Access Compliance Report

Public Rights-of-Way

(Curb Ramps)

Intersection ID: 48880	Main Street: TANGLEWOOD_LN	Cross Street: BRANDON_MANOR_LN	Location: NW
ADA ID: 08AB030B313B	Ramp Type: BlendTrans1	Initial Pass/Fail: Fail	Overall Compliance: No
Severity Score: 21.25			
Codes/Mitigation Info/Possible Solution		Field Measurements/Component Compliance

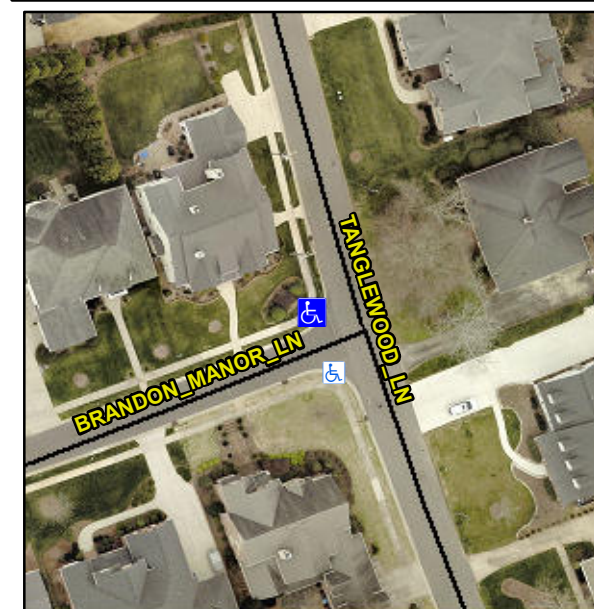
R304.5.1, R304.5.3

Compliance	Description	Data	Compliance	Description	Data
N/A	Ramp Length (in)	51.5	Yes	BlendTrans Slope (%)	4.0
No	Ramp Width (in)	43.5	No	BlendTrans XSlope (%)	5.3
N/A	Flare Type LT	N/A	N/A	Flare Type RT	N/A
N/A	Flare Slope LT (%)	N/A	N/A	Flare Slope RT (%)	N/A
N/A	Flare Traversable LT?	N/A	N/A	Flare Traversable RT?	N/A
N/A	Landing Length (in)	N/A	N/A	DWS Provided?	N/A
N/A	Landing Width (in)	N/A	N/A	DWS Contrast?	N/A
N/A	Landing Slope (%)	N/A	N/A	DWS Length (in)	N/A
N/A	Landing X Slope (%)	N/A	N/A	DWS Full Width?	N/A
N/A	Landing Curb? (Y/N)	N/A	N/A	DWS Offset (in)	N/A
N/A	Shared Landing?	N/A			
N/A	Gutter Ponding?	N/A	N/A	Gutter Slope (%)	N/A
N/A	Gutter Lip Ht (in)	N/A	N/A	Gutter X Slope (%)	N/A
N/A	Painted X Walk1?	No	N/A	Painted X Walk2?	No
	X Walk 1 Direction	To SE		X Walk 2 Direction	To NE
	X Walk 1 Width (in)	N/A		X Walk 2 Width (in)	N/A
	X Walk 1 Slope (%)	5.5		X Walk 2 Slope (%)	8.3
	X Walk 1 X Slope (%)	0.3		X Walk 2 X Slope (%)	3.1

Remove & Replace Curb Ramp With Two New Directional Ramps or Equivalent.
